**SAN ANTONIO WATER SYSTEM  
WEST VIEW TANK REPLACEMENT  
SAWS Job No. 15-6102  
Solicitation No. CO-00047**

**ADDENDUM NO. 3  
March 17, 2016**

**Consulting Engineer: River City Engineering, PLLC  
TBPE Registration No. F-1546**

SHEET NO. T-02

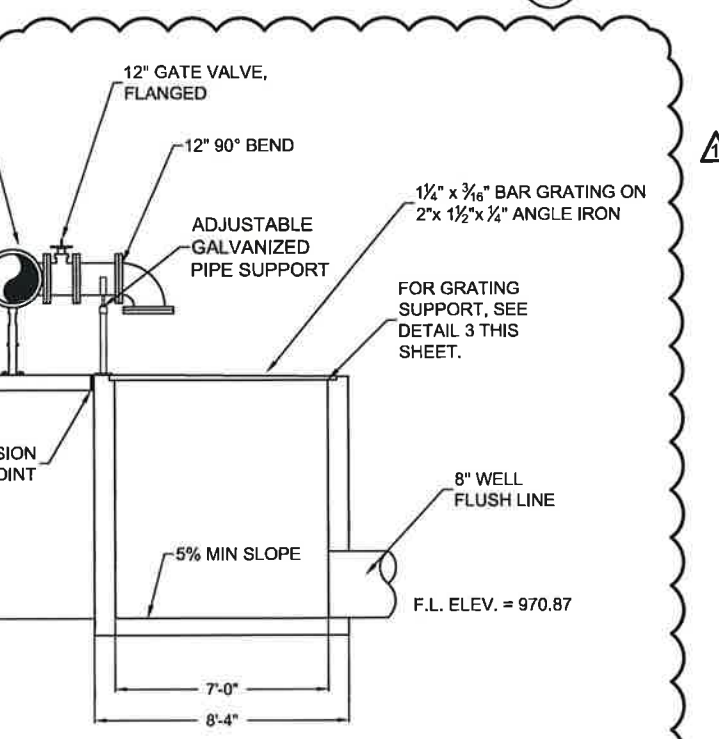
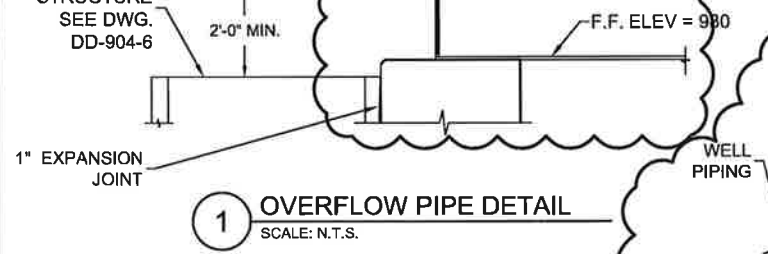
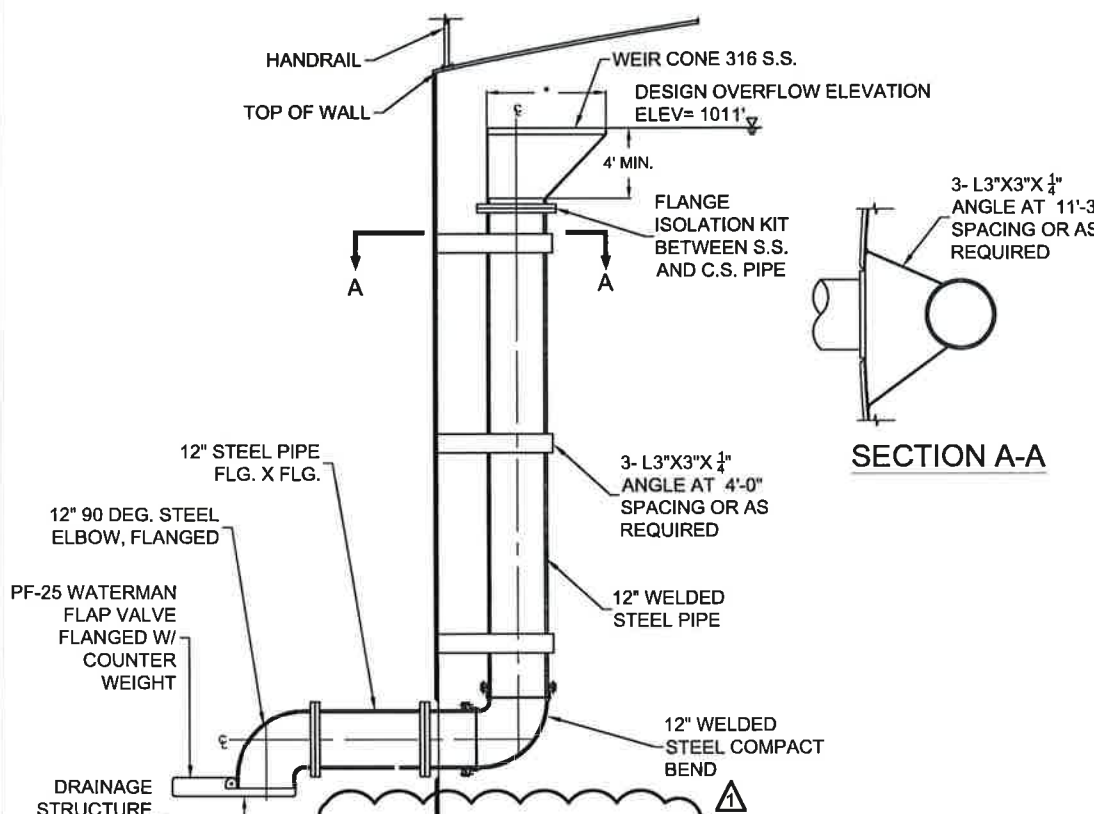
5. Question: The Plans indicate the 16" inlet pipe, 16" outlet pipe and 12" drain pipe entering the Ground Storage Tank through the floor. The details in the Plans show a concrete floor, similar to what would be used with a Pre-stressed, Pre-Cast Concrete Ground Storage Tank. The Plans also indicate a concrete ringwall foundation with a steel plate floor for the Ground Storage Tank. My question is, could the 16" inlet pipe, 16" outlet pipe and 12" drain pipe penetrate the Ground Storage Tank thru the tank sidewall, a more common installation for a Welded Steel Ground Storage Tank? If

11. Question: Plan Sheet C-07 indicates a 12" tank outlet. Detail 2 on Sheet T-02 indicates a 16" tank outlet. Please clarify.

20. Question: The Plan Sheets C-04 & C-07 indicate the outlet piping as wholly 12" in diameter. The Detail Sheet T-02 indicates the outlet piping initially as 16" in diameter. What size is the tank's outlet piping connection?

26. Question: Drawing 12 of 30-B Plan and Profile Views – The beginning construction point in plan view starts with a 12” WSP at the tank. The end point is a 12” WSP at the high service pump. The beginning and ending points are also illustrated on the profile drawing. Please see drawing 18 of 30 detail #2. Please explain how the 12” pipe shown on drawing 12 transitions to the 16” detailed on drawing 18. Perhaps the 16” under bottom pipe detailed on drawing 18 should be 12”. Please Verify.

27. Question: Drawing 18 of 30 – Details #1, #2 and #4 – Would it be possible to substitute FRP grating over the inlet and outlet holes in lieu of the stainless steel handrail shown? This alternate would preclude falling, and just as important, it would eliminate the galvanic action between the stainless steel handrail and the carbon steel tank floor. The neoprene gasket discussed in the notes will not stop electrical continuity between the dissimilar metals. Additionally, the FRP grating would act as an anti-vortex element.

Response: The inlet, outlet and drain pipe will enter the ground storage tank through the floor. Refer to Item Nos. 56 and 57 in the Drawings Section below and attached Sheets T-02 and T-03 for modifications.

Response: The tank outlet is now shown as 12 inches. Please reference Item No. 56 in the Drawings Section below and attached Sheet T-02 for modifications.

Response: The tank outlet piping has been changed to be 12-inches in diameter. Please reference Item No. 56 in the Drawings Section below and attached Sheet T-02 for modifications.

Response: The outlet pipe is 12-inches in diameter as clarified in this Addendum. Please reference Item No. 56 in the Drawings Section below and attached Sheet T-02 for modifications.

Response: The handrails shall be used as specified in the Contract Documents and shall be fabricated from carbon steel as clarified by this Addendum. Please reference Item No. 56 in the Drawing Section below and attached Sheet T-02 for modifications.

SHEET NO. T-03  
 19 OF 30 SHEETS

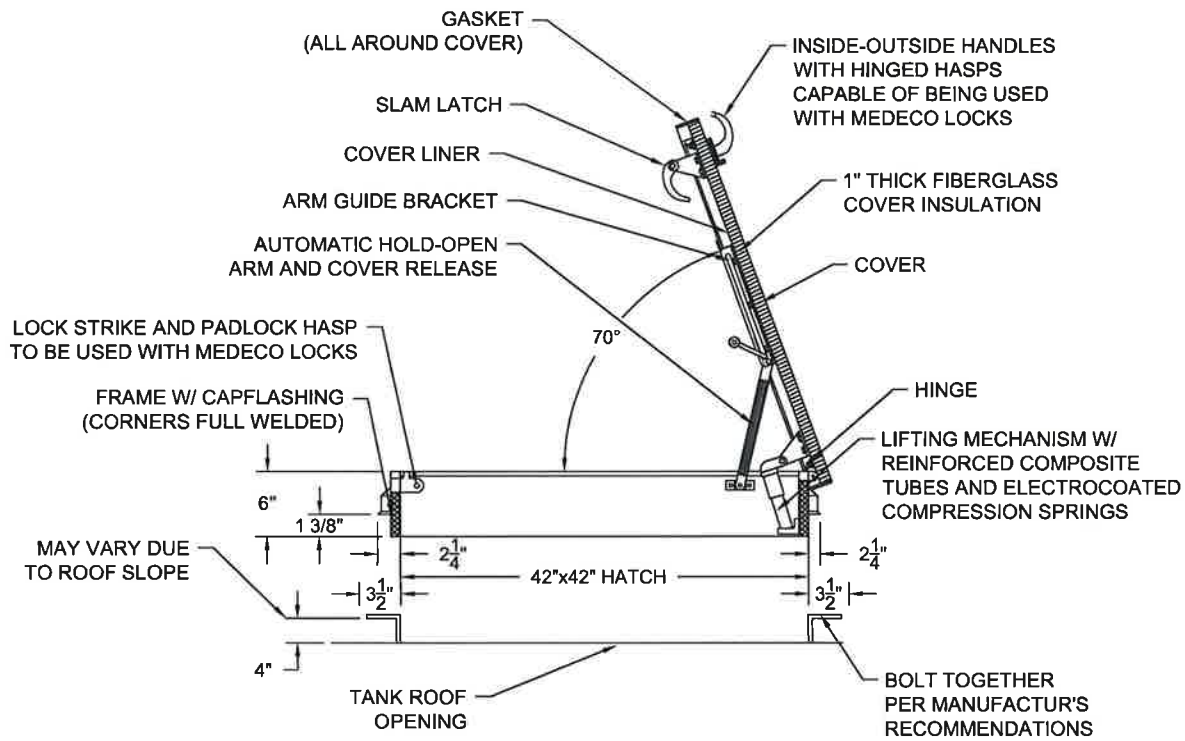
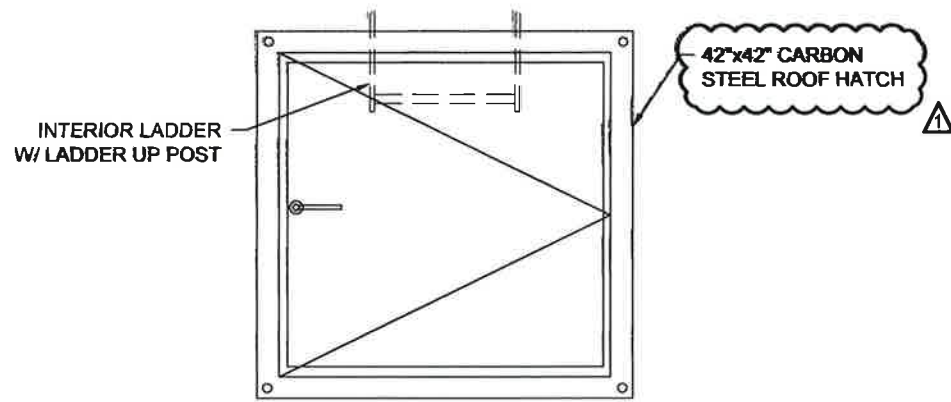
17. Question: The painting for the steel pipe inside the Ground Storage Tank is a fusion bonded epoxy coating which does not match the painting system specified for the Ground Storage Tank. Please clarify this is the owner's intention.

28. Question: Drawing 19 or 30 – Detail #2 – Again, we would suggest using an inert non-metallic grating such as FRP in lieu of stainless steel.

Response: The painting system for steel pipe inside the Ground Storage Tank should match the painting system specified for the Ground Storage Tank and has been clarified in the Addendum. Please reference Item 57 in the Drawings Section below and attached Sheet T-03 for modifications.

Response: The detail has been modified by this Addendum. Please reference Item No. 57 in the Drawings Section below and attached Sheet T-03 for modifications.

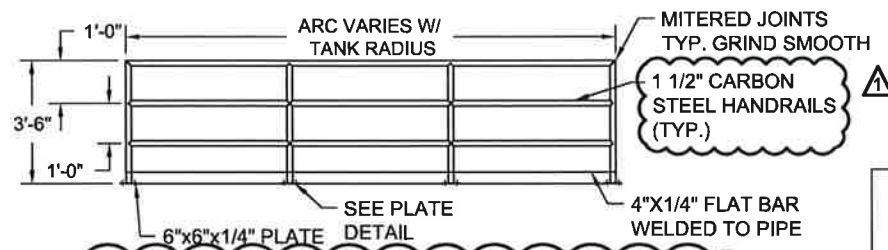
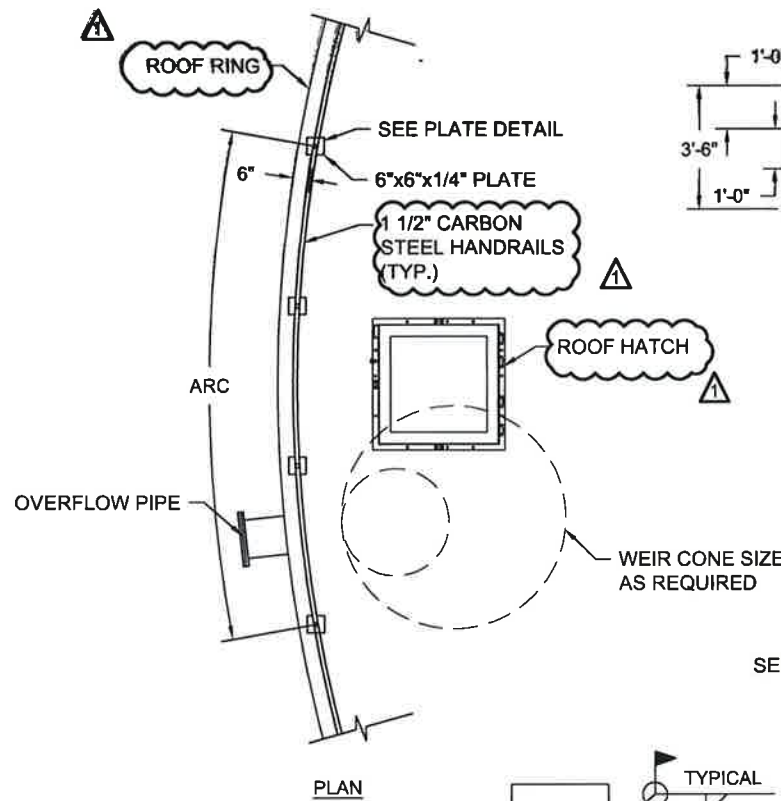
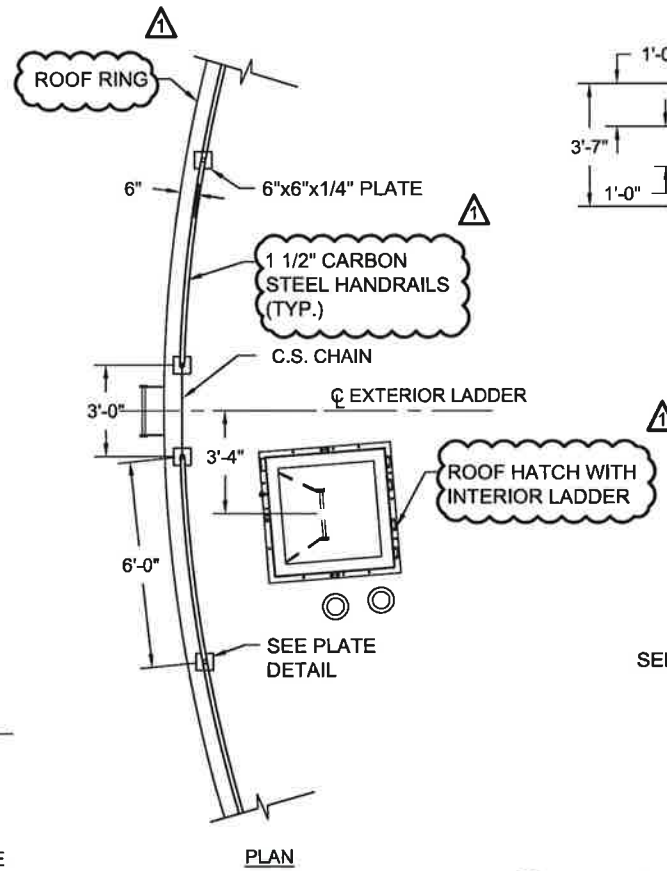
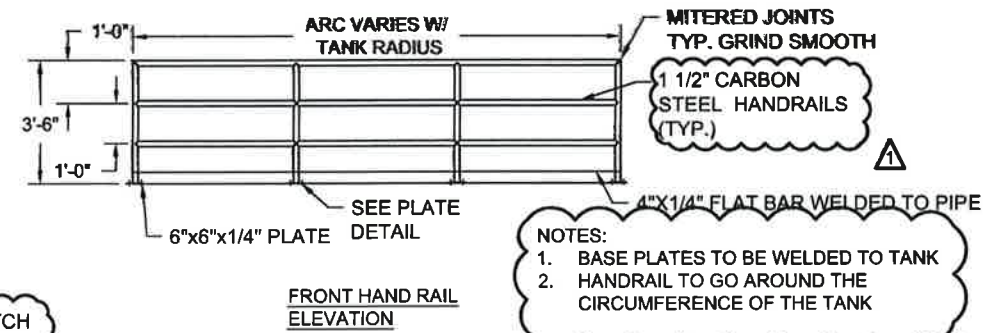
13. Question: The Specifications call for the tank roof hatches to be fabricated from carbon steel and the Plans call for the tank roof hatches to be fabricated from aluminum. Please clarify.

29. Question: Drawing 20 of 30 – Details #2 and #3 – Would it be possible to use carbon steel handrail painted like the tank exterior in lieu of stainless steel handrail.

38. Question: Please confirm that the roof handrail is to be fabricated utilizing stainless 316 steel. Sheet T-04 Calls out 1 ½" Sch 40, 316L C.S. Pipe Handrails.

Response: The tank roof hatches are to be fabricated from carbon steel only. Please reference Item No. 58 in the Drawings Section below and attached Sheet T-04 for modifications.

Response: A carbon steel handrail shall be used as clarified by this Addendum. Please reference Item No. 58 in the Drawings Section below and attached Sheet T-04 for modifications.

Response: The roof handrail is to be fabricated utilizing carbon steel as clarified by this Addendum. Please reference Item No. 58 in the Drawings Section below and attached Sheet T-04 for modifications.

**1** EXTERIOR LADDER DETAIL  
SCALE: N.T.S.

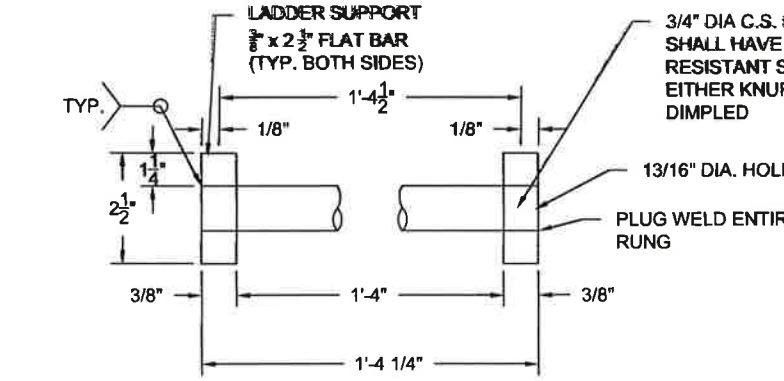
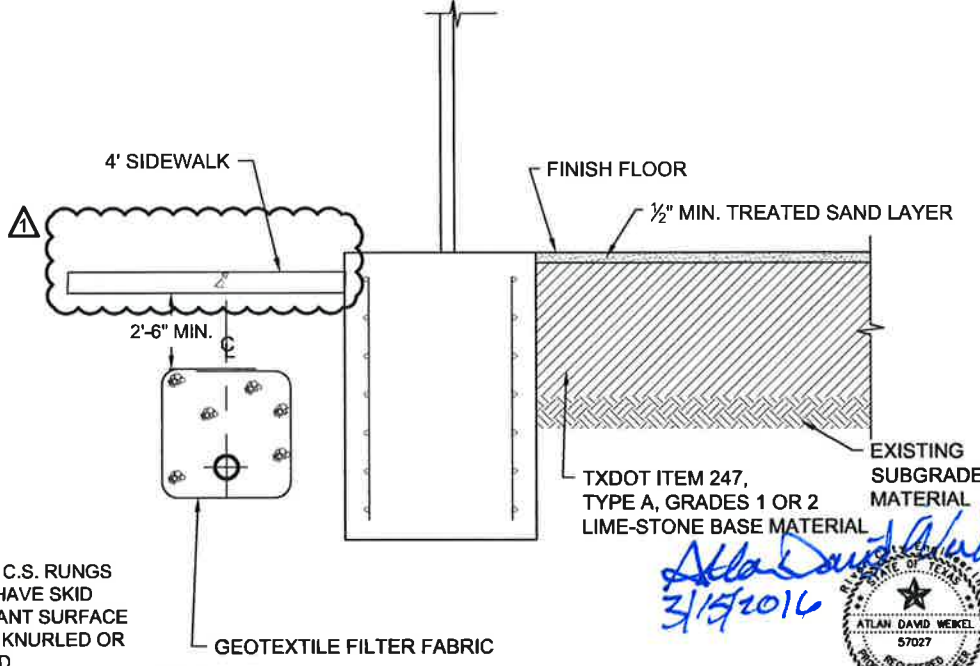
14. Question: The Plans call for the exterior tank ladder to be fabricated from both carbon steel and stainless steel. Please clarify.

Response: The exterior tank ladder is to be fabricated from carbon steel only. Please reference Item 59 in the Drawings Section below and attached Sheet T-05 for modifications.

NOTES:  
1. LADDER SHALL BE CARBON STEEL
